# ENVIRONMENTAL RE-EVALUATION FORM

State File #		Fed Project #	P027662	Project ID	P027662	Route	I-20/I-26/I-126	County	Lexington and Richland
--------------	--	---------------	---------	------------	---------	-------	-----------------	--------	------------------------

Project Name: I-20, I-26, I-126 Carolina Crossroads Corridor Improvements

# NEPA Re-evaluation

**CAROLINA CROSSROADS  
 I-26 WESTBOUND RAMP ONTO I-126  
 EASTBOUND AND COLONIAL LIFE BLVD**

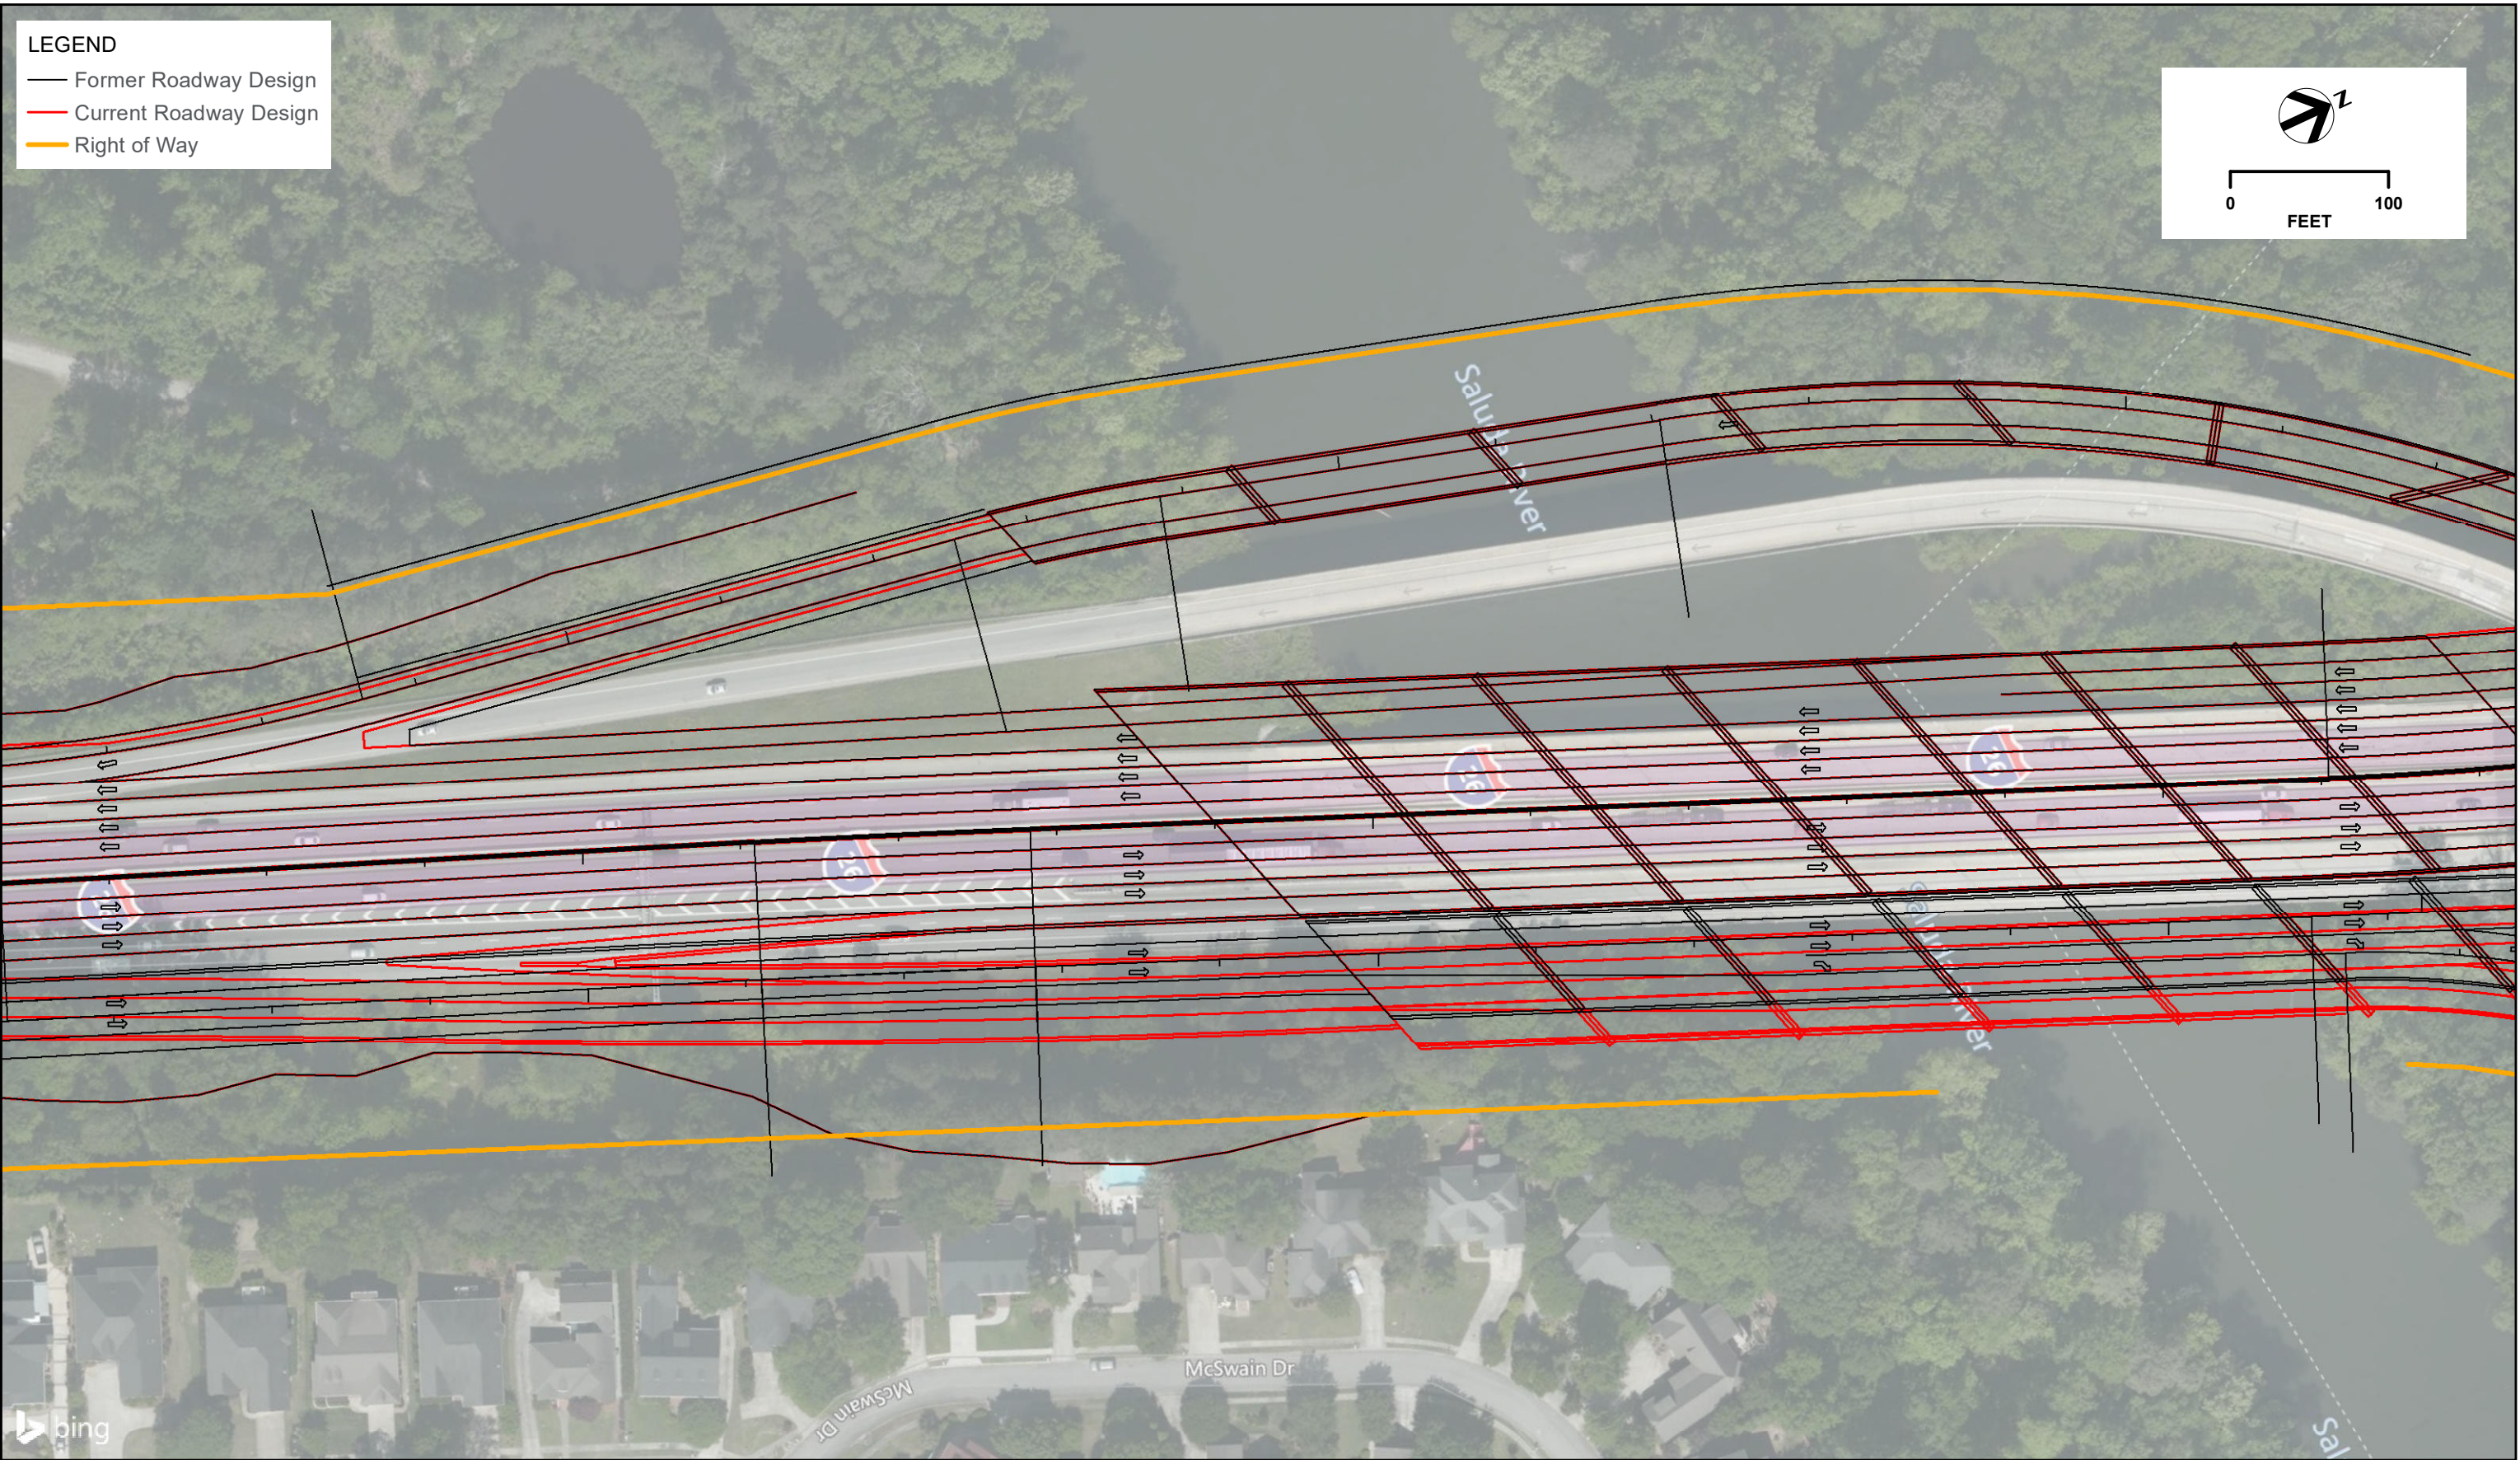
The proposed ramp alignment at the above location proposed in the RPA created a physical overlap between the ramp bridge and the existing I-26 Mainline Bridge over the Saluda River. Since the project is now being constructed in phases through multiple construction contracts and this ramp is constructed as part of the first phase, this physical conflict between the bridges must be resolved to allow the existing bridge to remain in service during construction and in the interim period between construction phases. To resolve this conflict, the ramp has been shifted away from the mainline approximately 20 feet. This change is just to the ramp geometry and does not change the operational function of the proposed exit from I-26 Westbound. The change occurs within the right of way proposed for the Refined RPA. See Figure 2.

As a result of this design change, the traffic noise analysis was updated to account for the ramp shifting closer to the Rivers Edge neighborhood by approximately 22 feet. The noise analysis concluded that the overall number of impacted receivers in the area did not change. The noise barrier analysis still found that a noise barrier at this location was not reasonable. See the Noise Analysis Update memo in Appendix A.

No other studies documented in the FEIS/ROD required updating as a result of this design change. No change of impacts presented in the FEIS/ROD are anticipated at this location.

**CAROLINA CROSSROADS  
 I-126 WB EXITS TO COLONIAL LIFE  
 BLVD. AND I-26 EB**

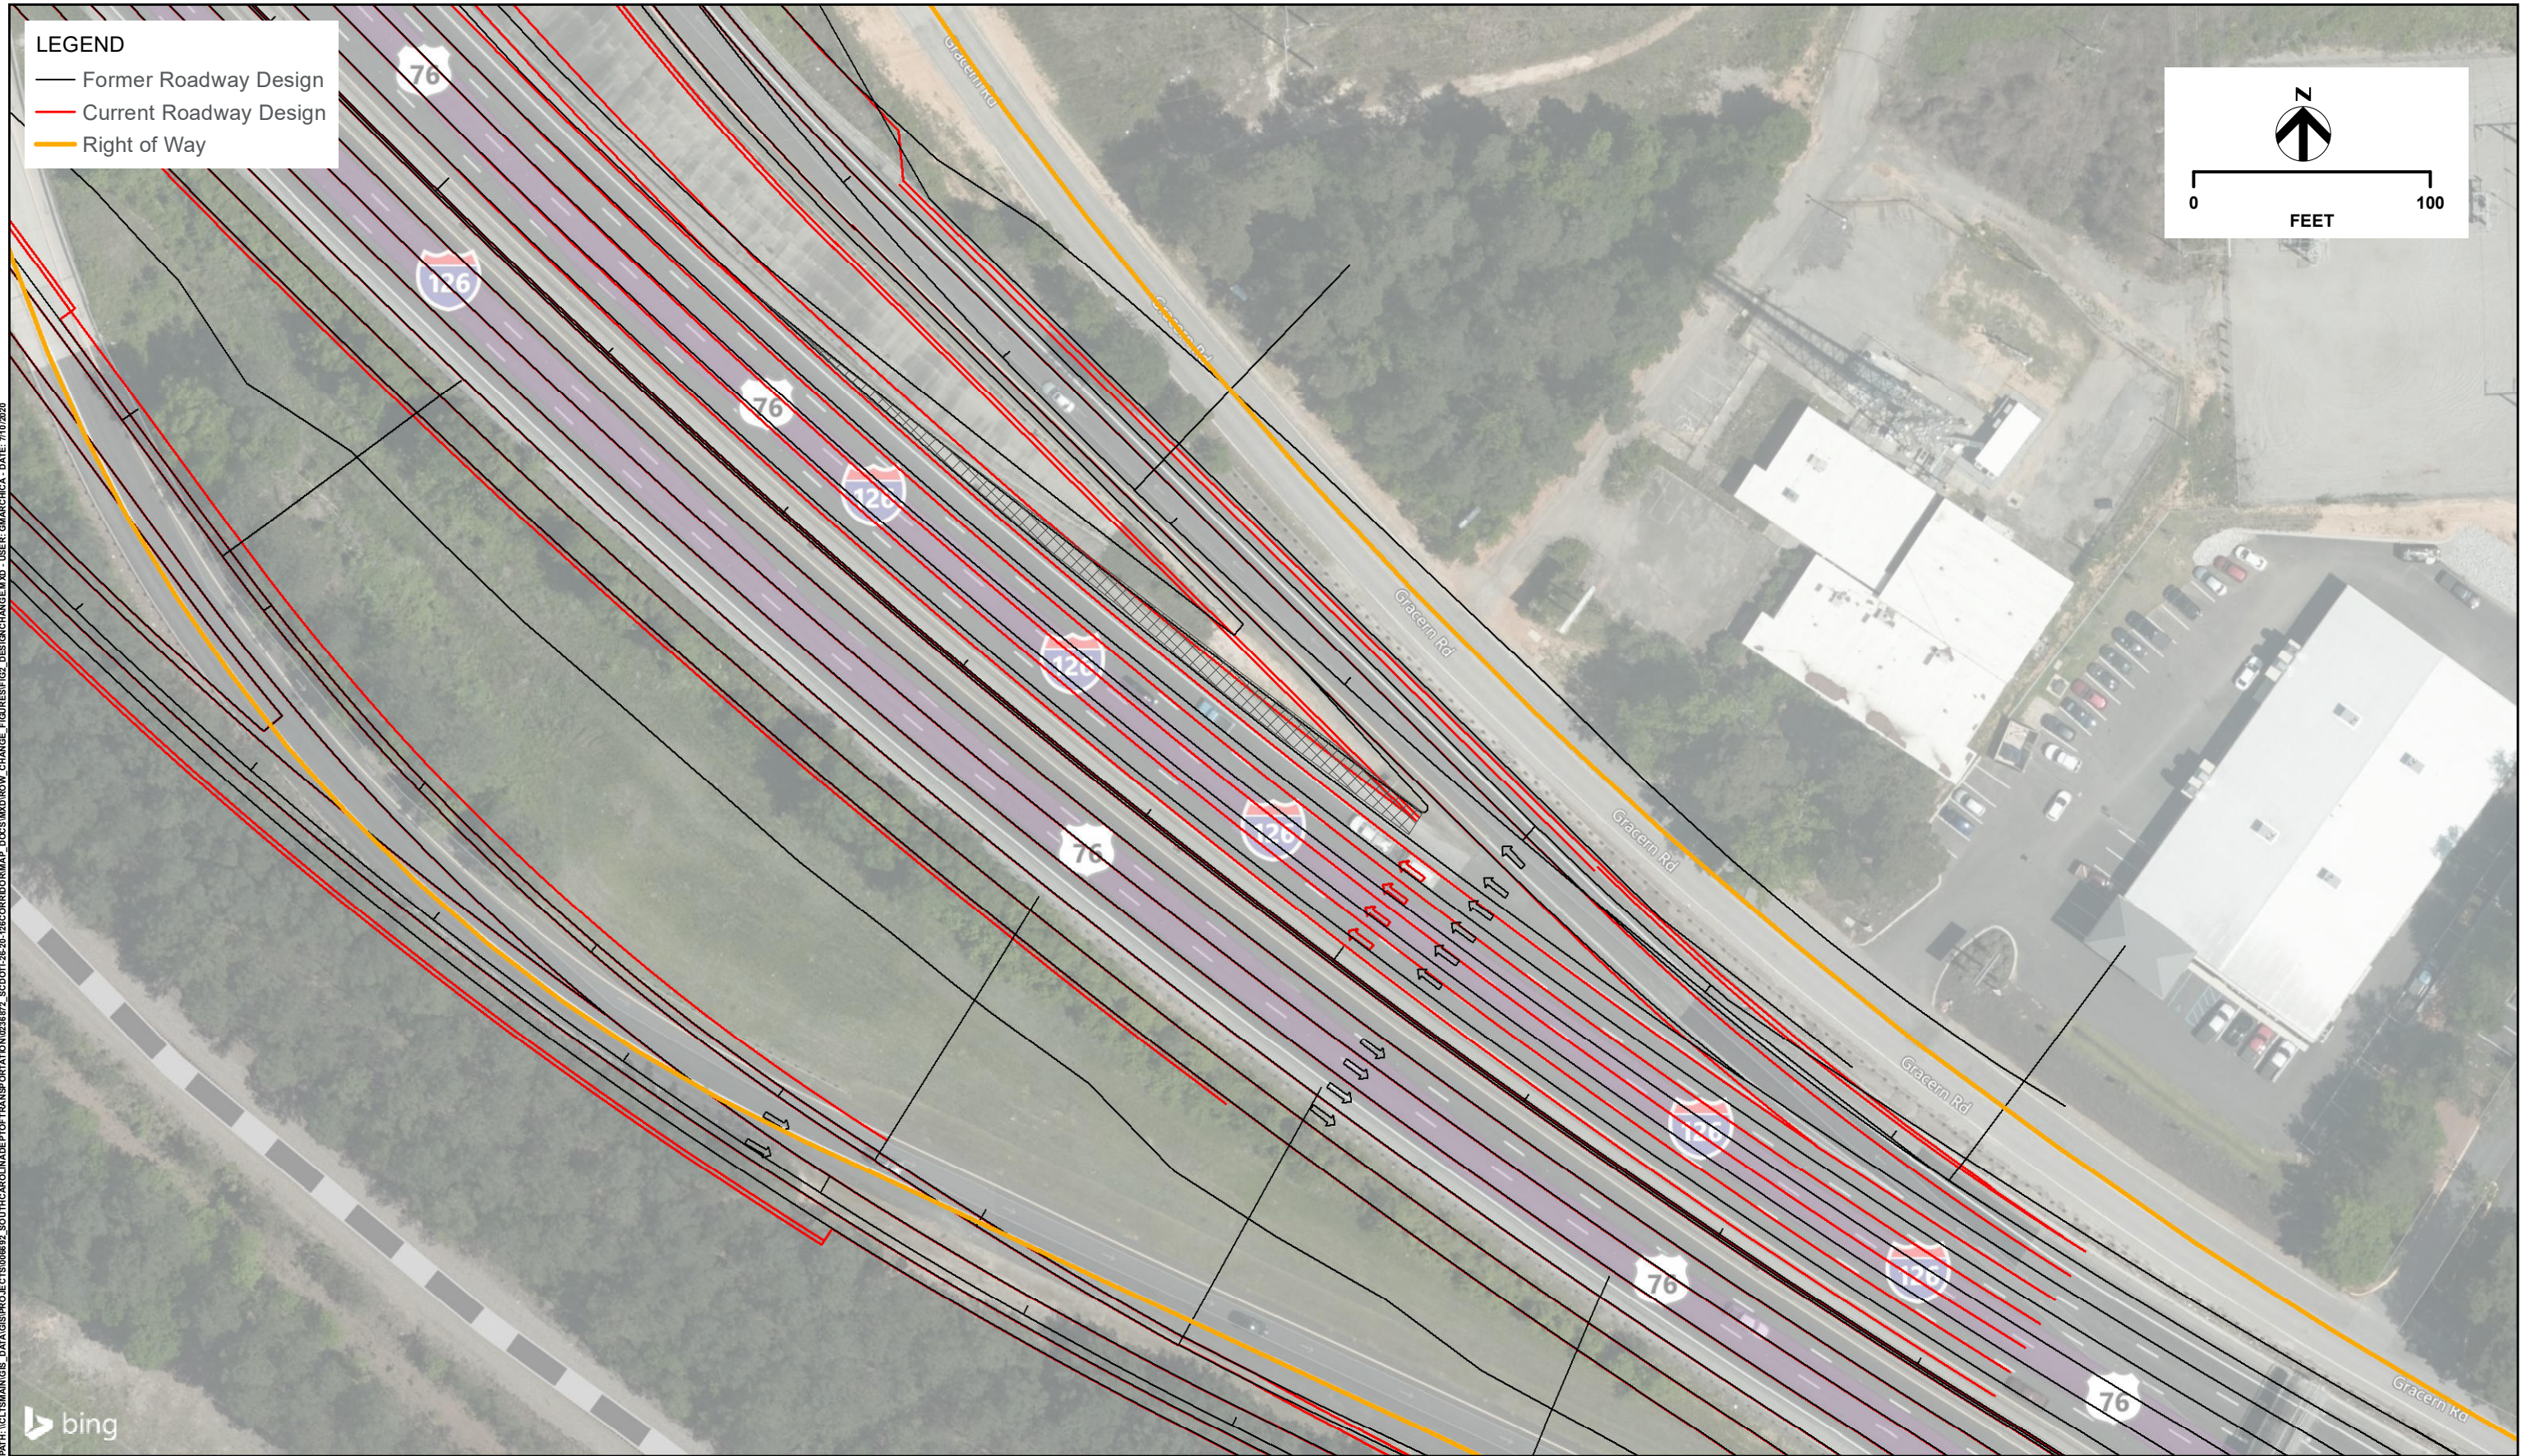
The Refined RPA included a five-lane approach along I-126 Westbound to the Colonial Life Blvd. exit with the exit to Colonial Life Blvd. being a tapered exit and all five through lanes extending through the exit. Beyond the Colonial Life Blvd. exit, the outside lane would become an “Exit Only” lane for the exit to I-26 Eastbound. During the design development, it was discovered that undesirable roadway design exceptions for lane and/or shoulder width would be required to allow for the five through lanes beyond the tapered exit to Colonial Life Blvd. The design was subsequently modified to retain the existing approach to the Colonial Life Blvd. parallel exit with four through lanes and immediately following the exit to Colonial Life Blvd., a deceleration lane for the exit to I-26 Eastbound is developed. This change was incorporated into the project traffic models and it was determined that this change will not adversely impact the I-126 westbound mainline operations during both the morning and afternoon peak hours. The change occurs within the originally proposed footprint of the roadway and within the right of way proposed for the Refined RPA. See Figure 3.

No environmental studies were updated based on this design change. No change of impacts documented in the FEIS/ROD are anticipated at this location.

**CAROLINA CROSSROADS  
SALUDA RIVER ACCESS ROAD**

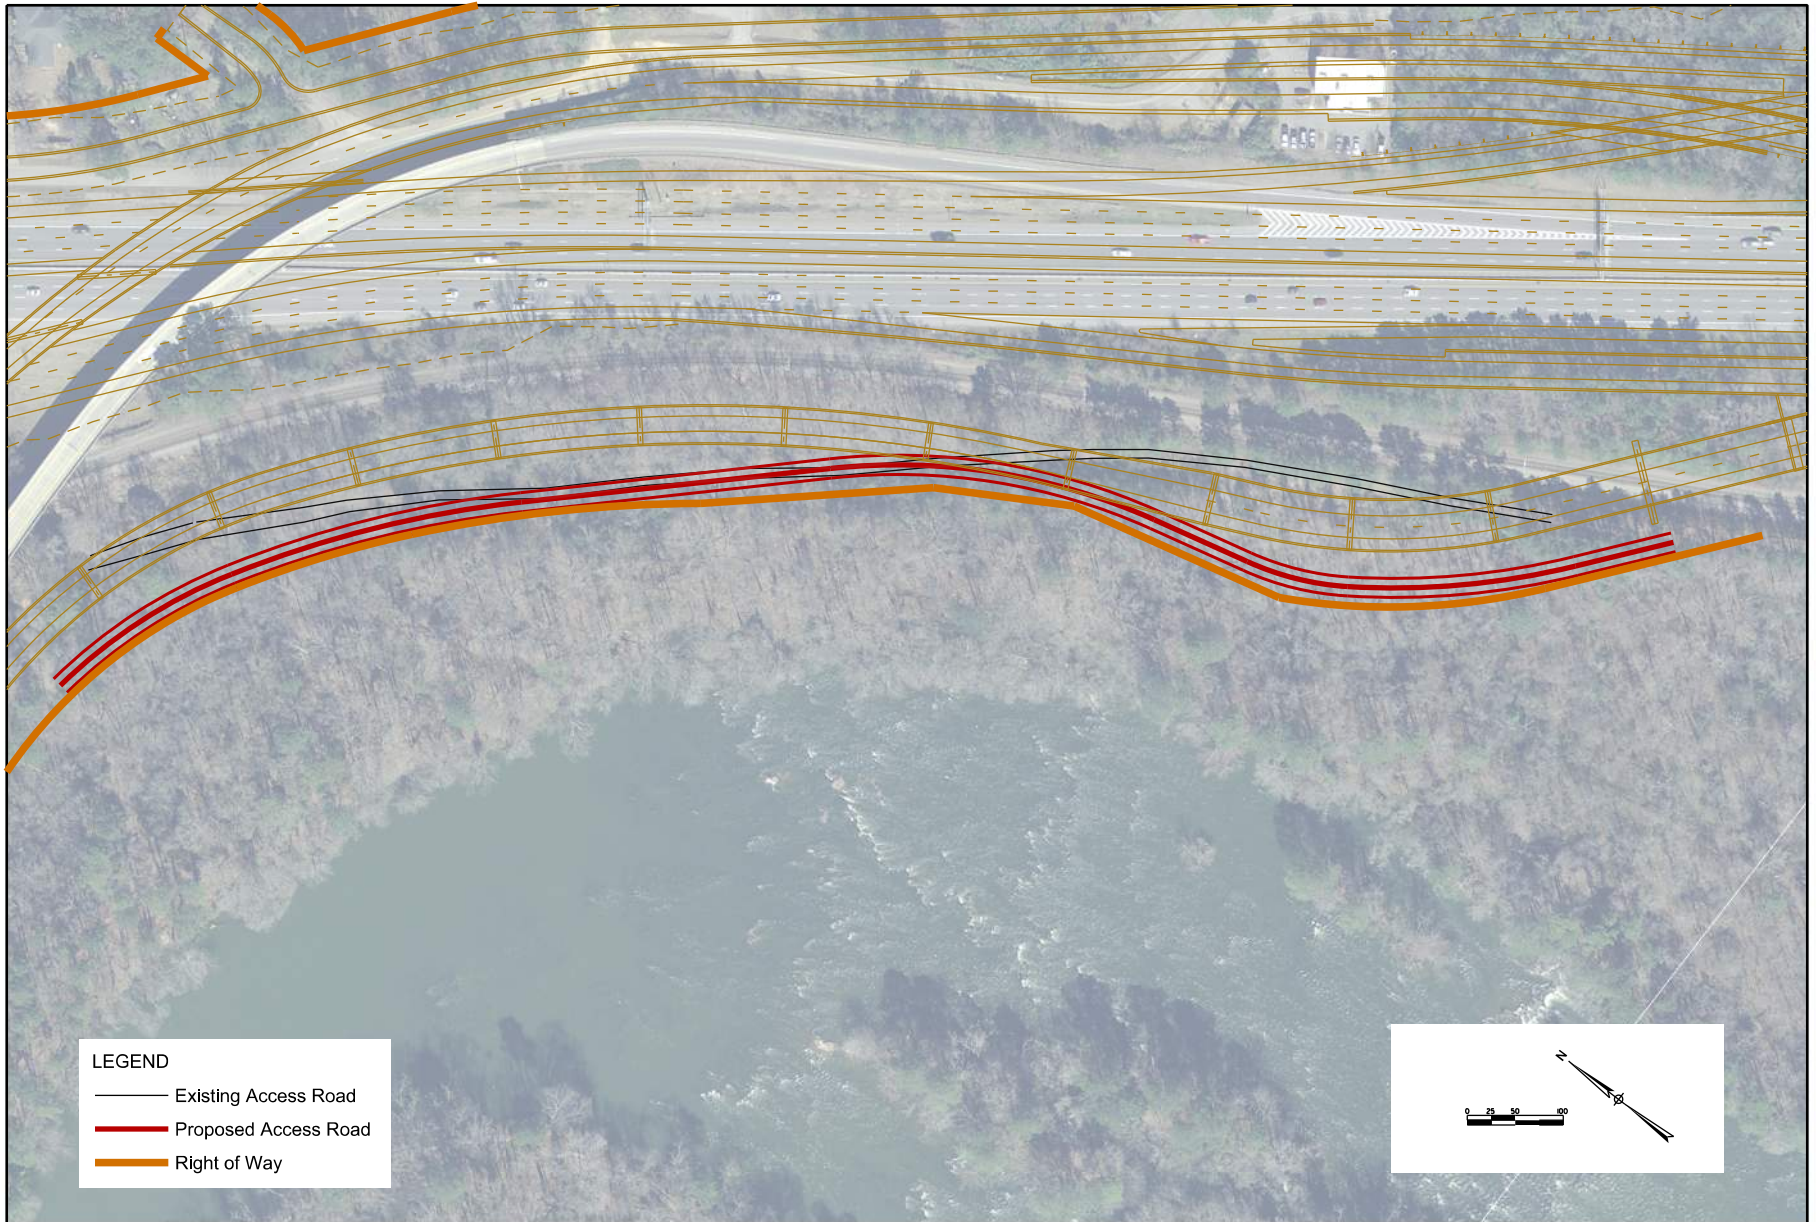
SCDOT is currently in the process of purchasing right of way for the project. During the negotiation process with Dominion Energy for the purchase of right-of-way along I-126 near the I-126/I-26 interchange, adjacent to the Saluda River, Dominion Energy identified an existing access/service road along the Saluda River that they currently used for maintenance of transmission lines and access for both the Saluda Riverwalk and Saluda River boat ramp. Emergency services also use the access road for emergency response to the trail and the boat ramp, which provides access for river rescues. The current design would require the elimination of the existing access road. SCDOT will be required to re-establish this access road within the proposed right of way acquired for the Carolina Crossroads project. The relocated roadway is expected to be reconstructed along the right of way line, adjacent to I-126 and the interchange ramps. The road was designed to avoid impacts to the Saluda Canal, which is an historic resource. See Figure 4. The proposed relocation of the access would increase impacts for Wetlands 25 and 26 by a total of 0.24 acres of fill and 0.19 acres of clearing and Tributaries 45 and 46 by a total of 53 linear feet. However, the overall wetland and stream impacts included in the USACE Individual Permit (IP) are lower than the impacts documented in the FEIS/ROD, as noted in Table 1.
